**Subject:** Inspection of the trim tab hinges

**Concerned:** G 115/ G 115A/ G 115B, all S/N's  
G 115C, G 115C2, G 115D, G 115D2, all S/N's

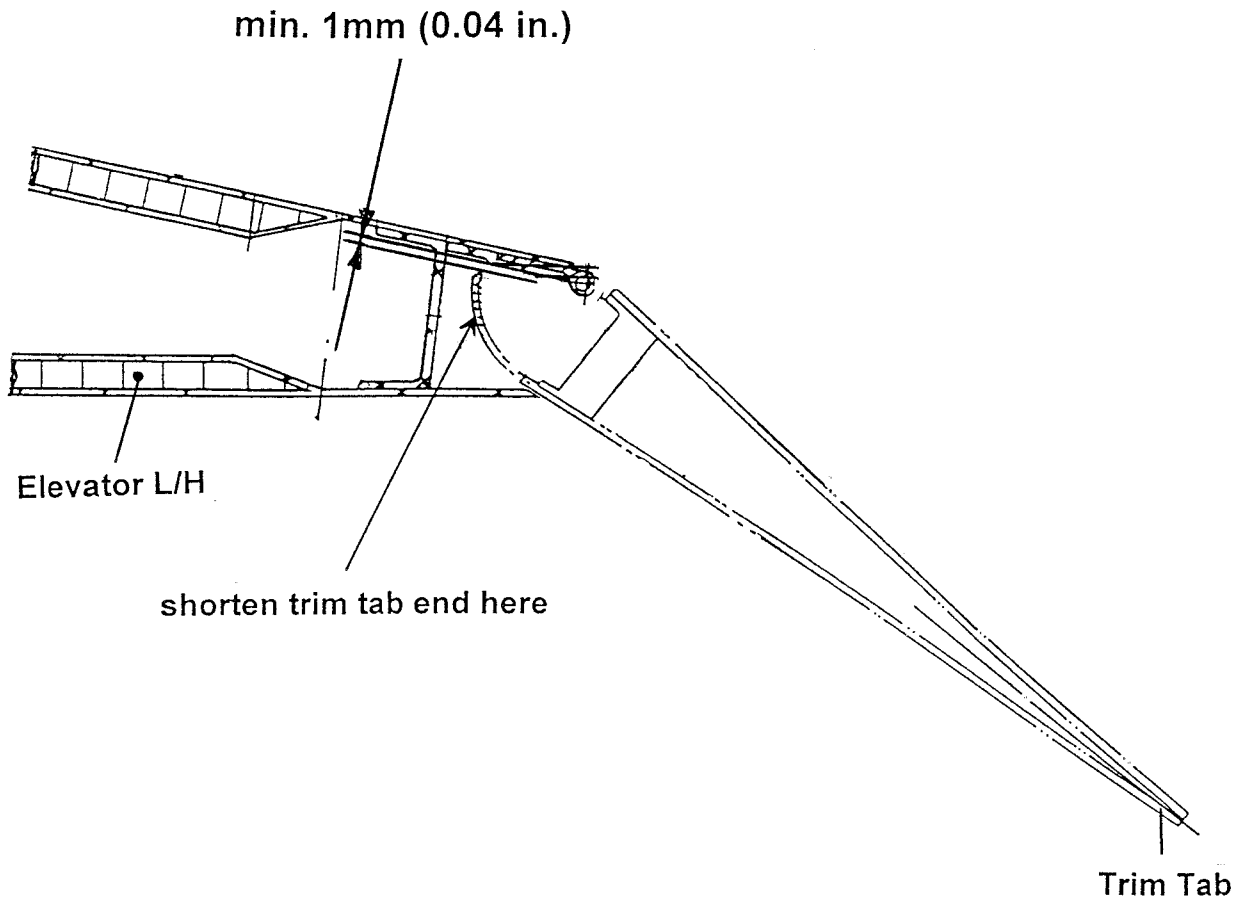
1. The trim tab hinges (qty. 4, as of S/N 82078 qty. 5) must be checked visually (perhaps using a magnifying glass, 10 times magnification) for cracks and tight fit in the laminate (especially in the area of the marked hinge, item 1, because the cracks were found in this area) and the result must be filed in the attached "**Inspection Record**". In any case of doubt the trim tab has to be removed according to MM Chapter 55-20-00 and must be checked. Damages must be repaired according to the Repair Instructions No. 1078-75.

2. Check, whether the trim tab end touches the upper elevator shell as follows:
  - trim the trim tab to fully nose up
  - measure deflection and note value, if necessary adjust (refer to the corresponding MM)
  - push elevator fully
  - check whether **minimum 1 mm (0.04 in.) gap** is ensured between the end of the trim tab and the upper elevator shell using a pocket lamp and thickness gauge
  - if no or a too small gap is found, remove the trim tab and shorten the end of the trim tab as far as minimum 1mm (0.04 in.) gap exists
  - check weight and residual moment of the trim tab according to the MM Chap. 06-00-00 and file the values
  - install trim tab according to the MM Chap. 55-20-00 and check or adjust deflection according to the MM Chap. 06-00-00

**1. Inspection of the trim tab hinges**

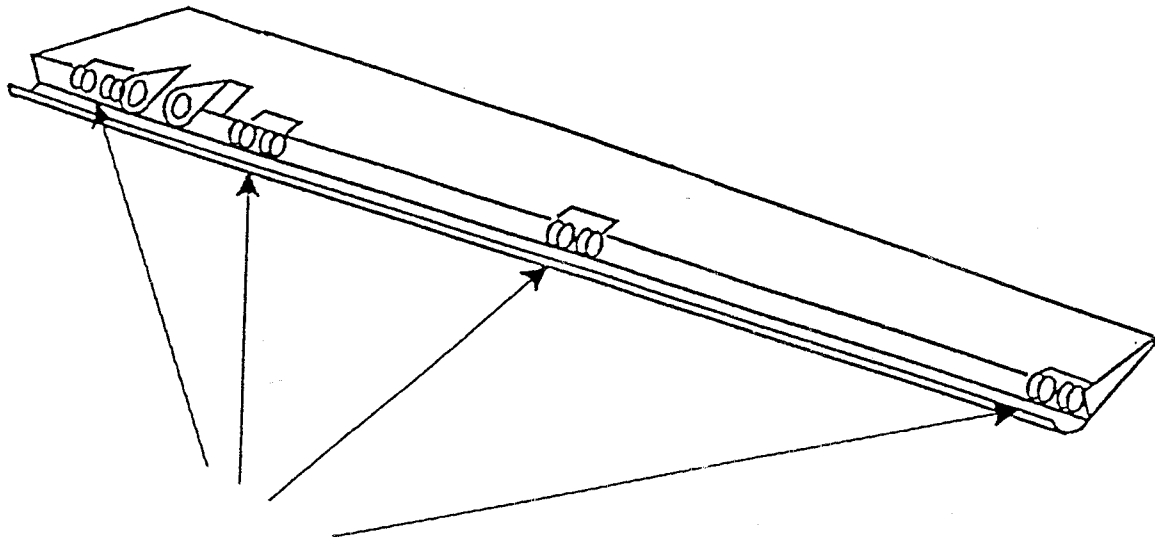
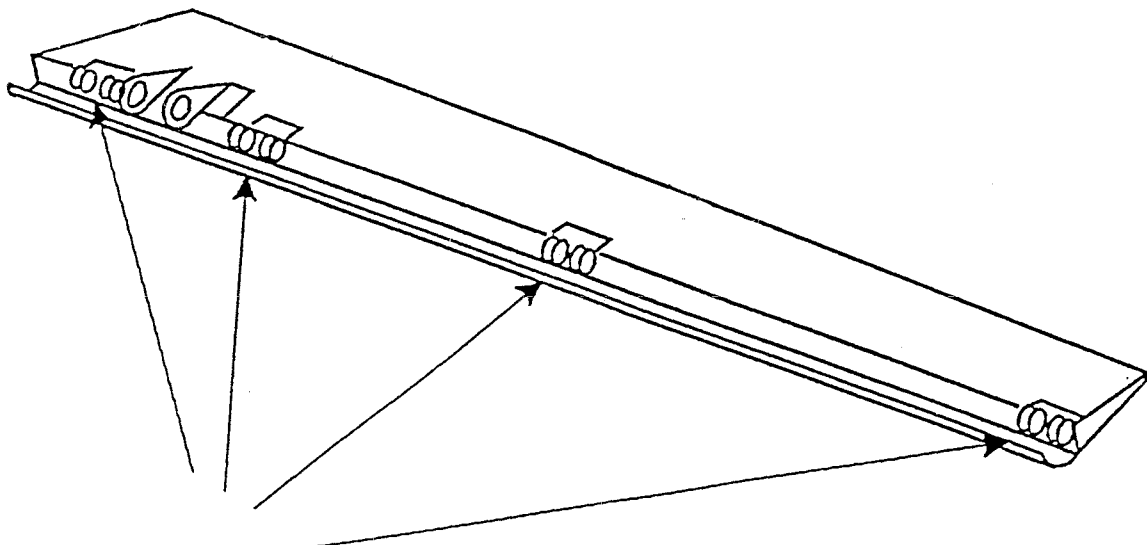
a. Have cracks been detected (mark length and position) ? YES NO

b. Were hinges delaminated (mark position)? YES NO

**2. Check of the gap between trim tab end and upper elevator shell**

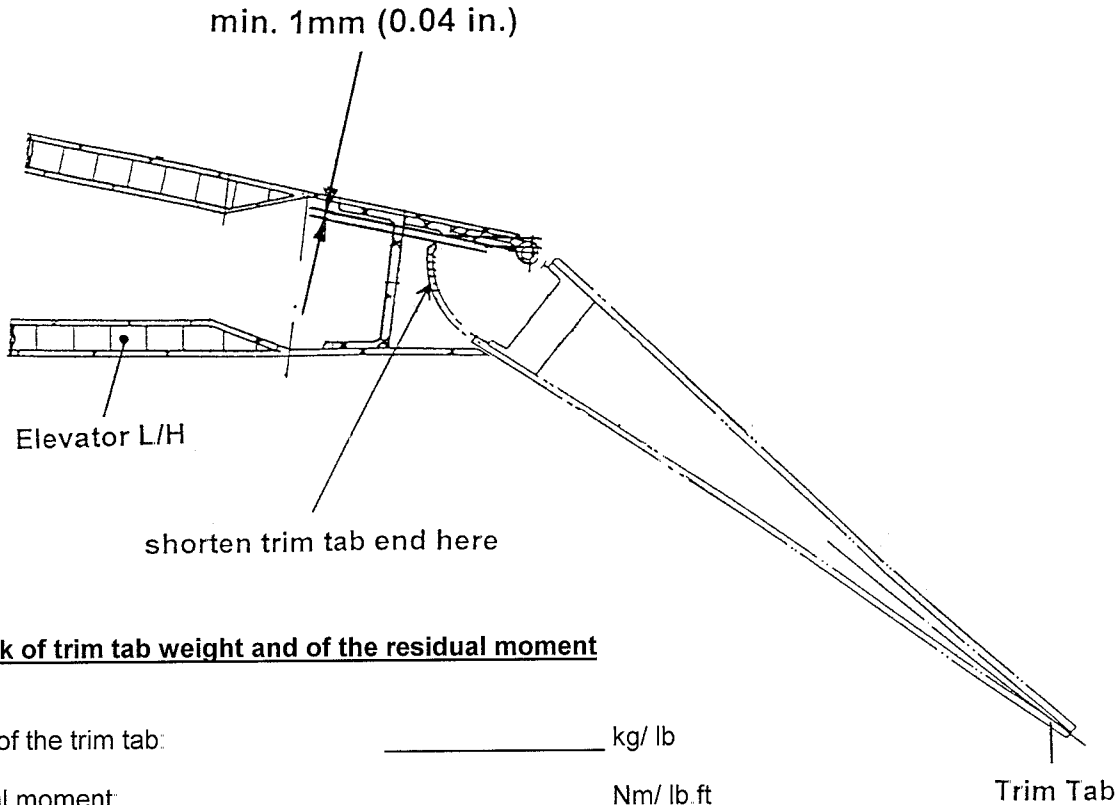
Gap minimum 1 mm (0.04 in.)?

Trim tab end was shortened:
